UNITED STATES PATENT AND TRADEMARK OFFICE

APPLICATION NO.	FILING DATE	FIRST NAMED INVENTOR	ATTORNEY DOCKET NO.	CONFIRMATION NO.
10/775,934	02/09/2004	Arnd Kausch	71229	3171

Office Action Summary

Figure 2
Prior Art: US 4513452

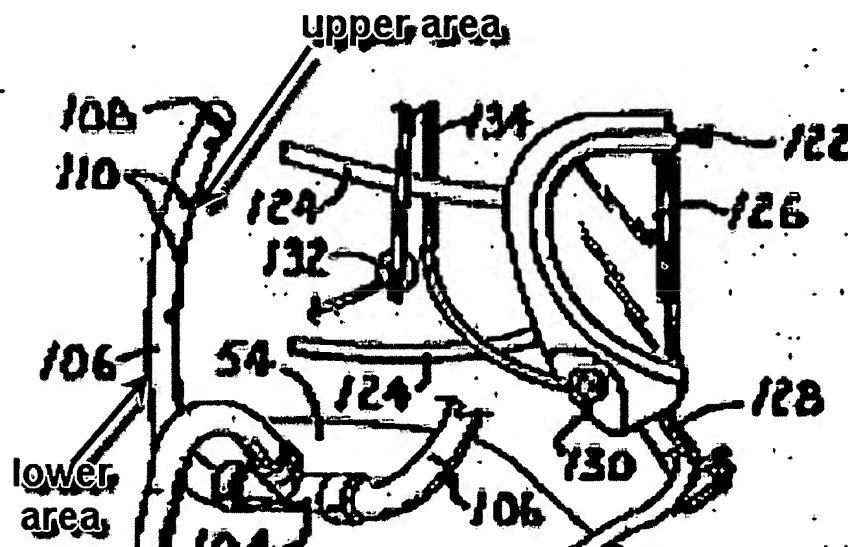
Claims 1, 3-5, 8, 10-12, and 15 are rejected under 35 U.S.C. 102(b) as being anticipated by Rankin, Sr. et al. Rankin, Sr. et al. disclose a device for supplying breathing air in an interior of safety clothing, the device comprising a connection means 70 to a compressed air source 66 for providing breathing air; and a hose system which is connected to said connection means 70 from which breathing air enters said interior of said safety clothing, wherein said hose system further comprises a permeable tube section made porous (apertured tube 106). Rankin, Sr. et al. further disclose the permeable tube section 106 is formed in a horizontally extending semicircle and is placed at level of a neck part of a

user of said safety clothing (see Figure 2). The horizontally extending semicircle 106 further comprises a lower area and an upper area wherein said lower area is sealed and said upper area is porous (See Figure 2 below).
